STAFF REPORT

SUBJECT: H-2020-0117
Shafer View Terrace – AZ, PP

Annexation of a total of 40.48 acres of land with R-2 (10.66 acres) and R-4 (29.82 acres) zoning districts; and Preliminary Plat consisting of 50 buildable lots and 10 common lots on 39.01 acres of land in the R-2 and R-4 zoning districts.

B. Preliminary Plat & Phasing Plan (date: ~~11/18/2020~~ 3/9/2021)

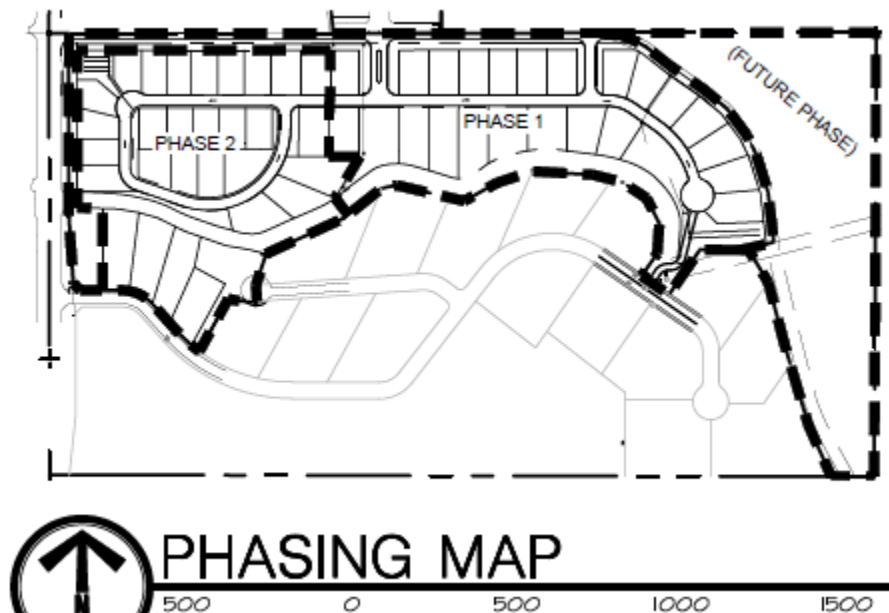
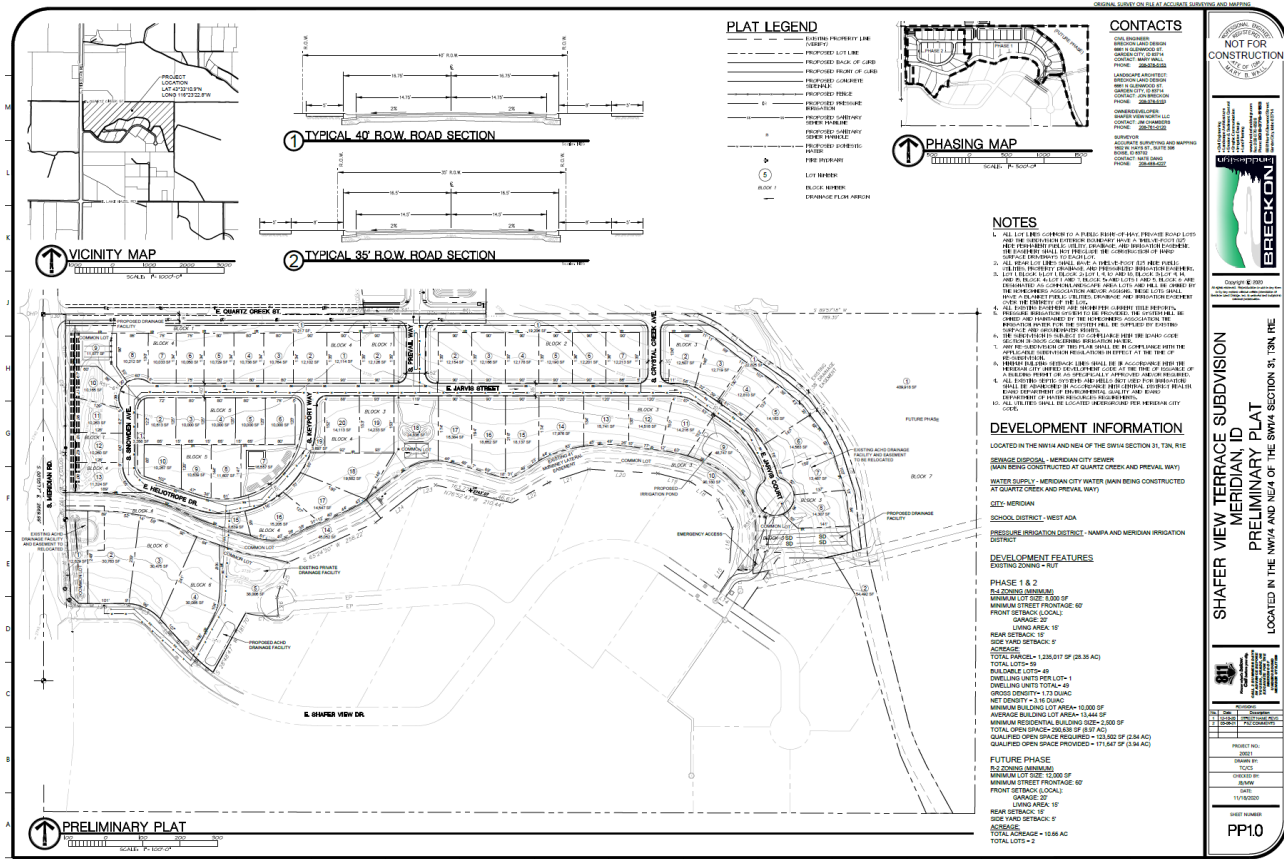
The face of Block 3 exceeds 1,200' and does not provide a pedestrian connection other than the emergency access driveway which may serve as a pedestrian connection between the proposed subdivision and Shafer View Estates to the south. **The Applicant requests City Council approval of the proposed block length due to existing site constraints that include the following: 1) the narrow configuration of the subject property; 2) the location of the McBirney Lateral, a large waterway/irrigation facility, that runs along the southern boundary and through the western portion of the proposed subdivision; and 3) the existing Shafer View subdivision that abuts the site to the south, south of the lateral, which does not include any pedestrian pathways or stub streets to this property. If not approved, the plat should be reconfigured to comply with this standard. An emergency access road for Fire Dept. is proposed between the end of the cul-de-sac and E. Shafer View Rd. but it's not a public access.**

- b. Block 3 exceeds the maximum block face standards listed in UDC 11-6C-3F; the plat shall be revised to comply with these standards unless otherwise approved by City Council. *A waiver is requested from Council to exceed the maximum block face allowed of 1,200 feet to allow the block face as proposed.*

- ~~c. The 38' wide drain on the eastern portion of the site shall be contained entirely within a common lot(s). Depicted on revised plat.~~
 - ~~d. Remove one (1) buildable lot in the vicinity of Lots 2-5, Block 6 south of the McBirney Lateral. Depicted on revised plat.~~

C. Landscape Plan (date: ~~5/17/2020~~ 2/3/2020 3/9/2021)

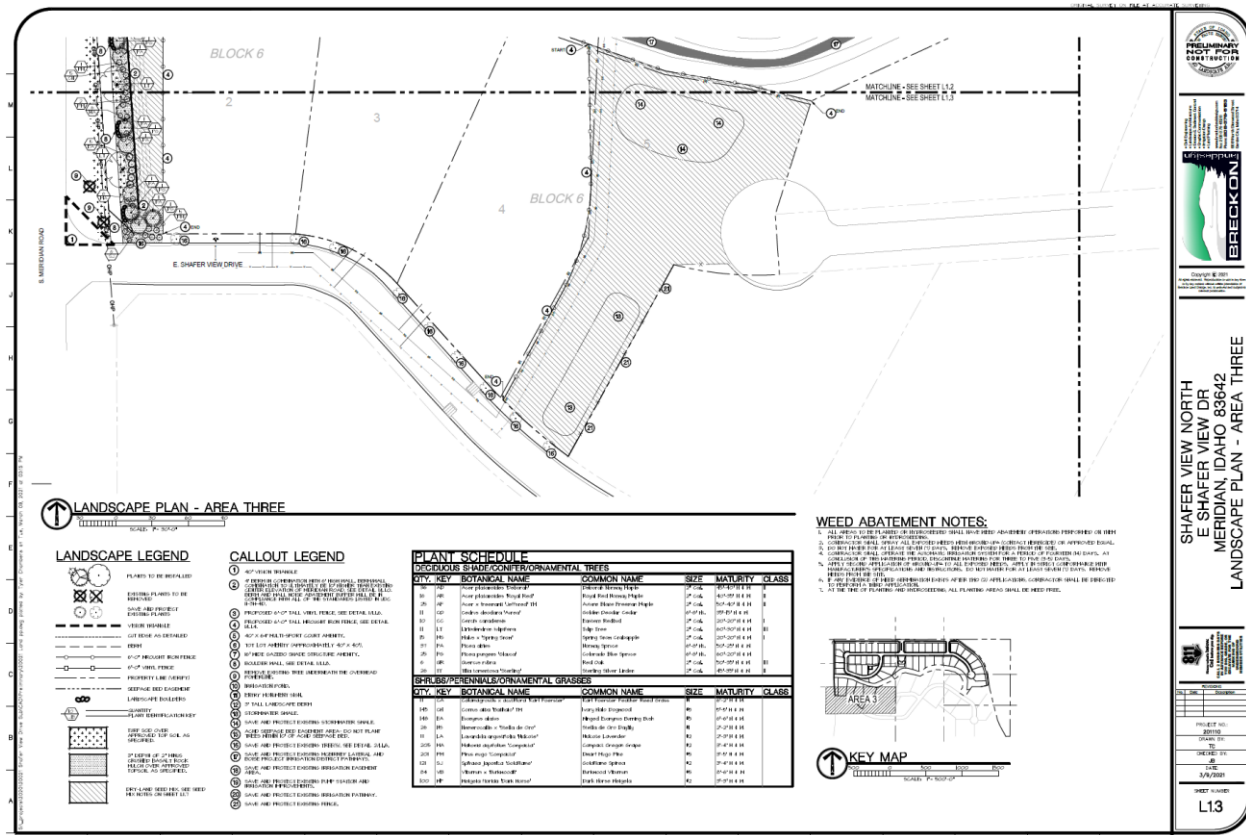
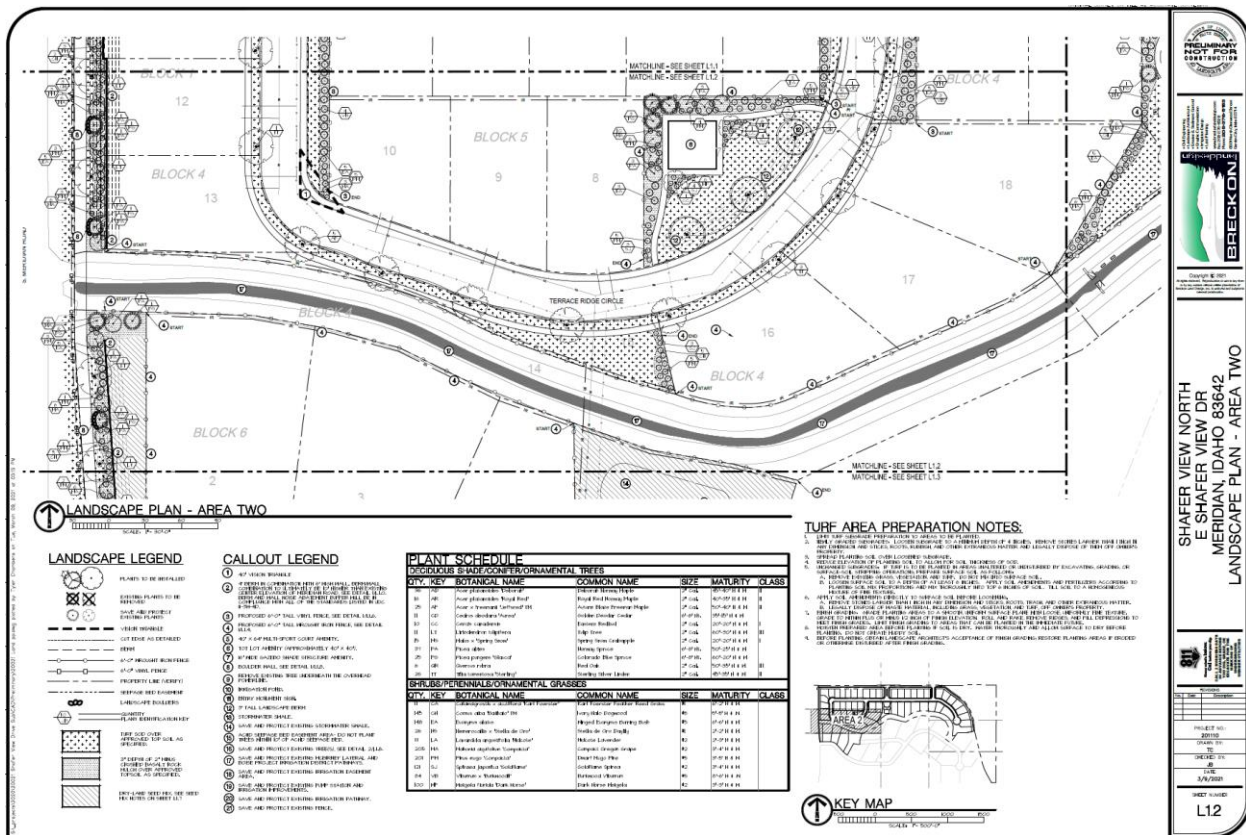
Landscaping is required adjacent to the pathway along S. Meridian Rd./SH-69 per the standards in UDC [11-3B-12C](#). A 5' wide landscape strip is required on both sides of the pathway planted with a *mix* of trees, shrubs, lawn and/or other vegetative ground cover. **The Landscape**

Requirements table should include the linear feet of pathway with the required vs. proposed number of trees to demonstrate compliance with UDC standards.

Landscaping is required within parkways per the standards listed in UDC [11-3A-17](#) and [11-3B-7C](#). **The Landscape Requirements table should include the linear feet of parkways within the development with the required vs. proposed number of trees to demonstrate compliance with UDC standards.**

A 4-foot tall berm with a 6-foot tall solid wall by Simtek is proposed along S. Meridian Rd. as noise abatement as depicted on the detail on Sheet L1.0 of the Landscape Plan. Architectural elements are proposed to break up monotonous wall planes as required. **~~A detail of the proposed wall that demonstrates compliance with the standards listed in UDC 11-3H-4D should be submitted with the final plat for the first phase of development.~~** *Depicted on the revised landscape plan.*

4. The landscape plan included in Section VII.C ~~submitted with the final plat~~ shall be revised as follows:
 - ~~a. Include calculations in the Landscape Requirements table that demonstrate compliance with the standards for pathway (11-3B-12C) and parkway (11-3B-7C) landscaping; include required vs. provided number of trees. Done~~

- ~~c. Include a detail of the berm and wall required for noise abatement along S. Meridian Rd./SH-69 that demonstrates compliance with the standards listed in UDC 11-3H-4D. Done~~
